MONTGOMERY COUNTY HISTORIC PRESERVATION COMMISSION
STAFF REPORT

Address:	7312 Willow Ave., Takoma Park	Meeting Date:	5/21/2019
Resource:	Contributing Resource Takoma Park Historic District	Report Date:	5/14/2019
Applicant:	Nancy Hughes & Tim Rahn	Public Notice:	5/7/2019
Review:	HAWP	Tax Credit:	Partial
Case Number:	37/03-19U	Staff:	Dan Bruechert
PROPOSAL: Porch Alterations, fence construction, hardscape alteration

PROPOSED FRONT ELEVATION.

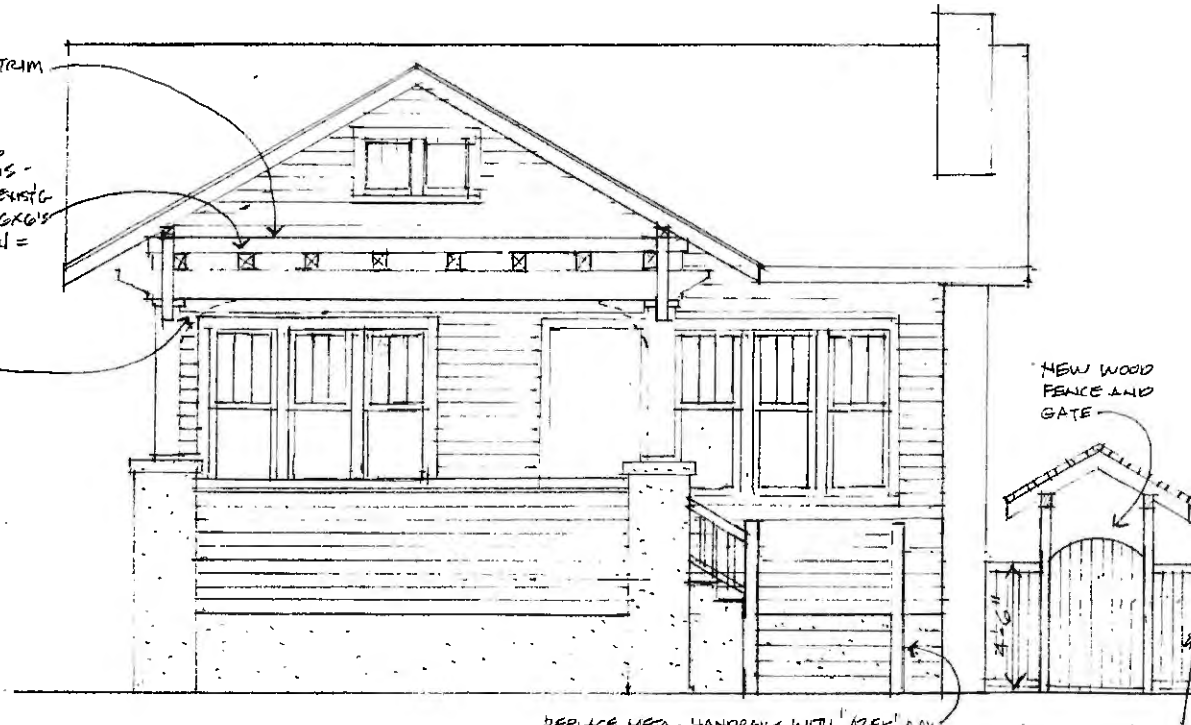
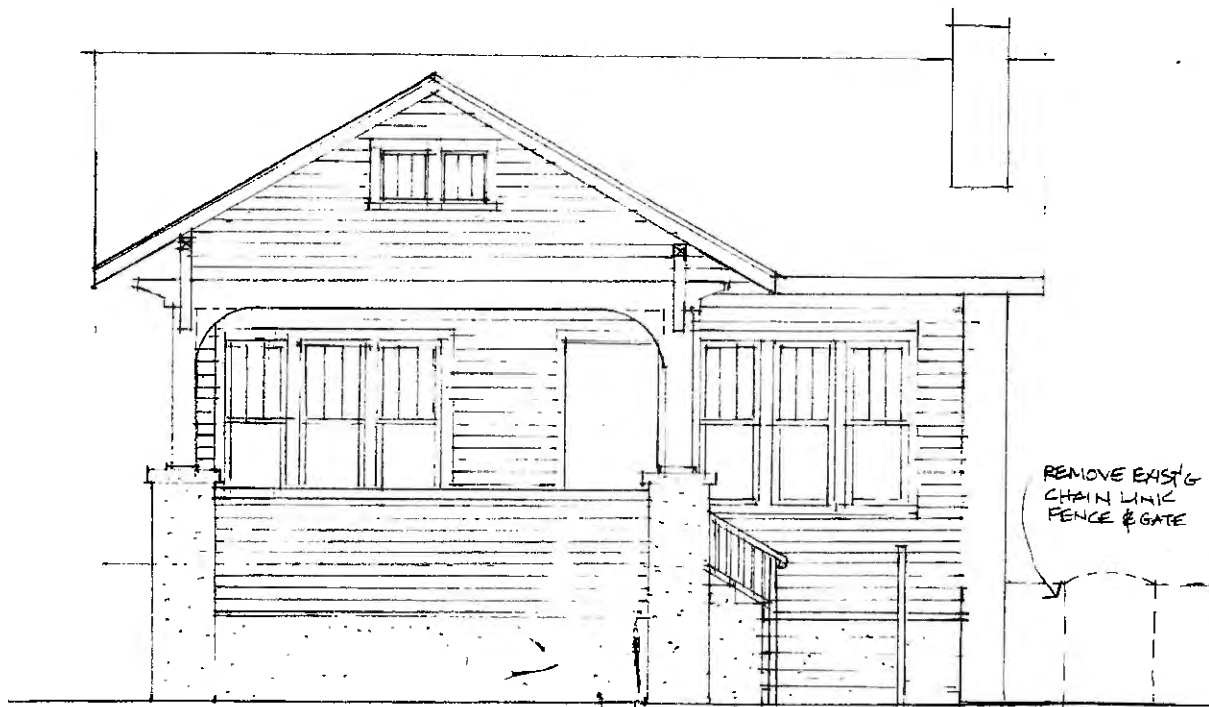
1. The proposed porch railing needs to be constructed out of wood, not the proposed Azek.
Permit drawings submitted for review need to satisfy this condition.

The applicant further proposes to replace the existing, iron, hand rail with a simply detailed Azek handrail. Staff finds that the iron is not in keeping with the historic character or appearance of the house and its removal will not impact the historic character. The proposed railing material should be compatible with the historic house and surrounding streetscape. Staff finds that the proposal should utilize traditional materials, with finishes and aging that is consistent with traditional materials. This is all the more significant in this location, because the material is on the first floor at the front of the house and will be more visible from the right-of-way and will be physically touched on a daily basis. Staff finds that the appropriate material is wood. Staff recommends the HPC add a condition for approval that the front railing be constructed out of wood. Staff can confirm that this condition has been met upon submission of permit drawings.

1. The proposed porch railing needs to be constructed out of wood, not the proposed Azek.
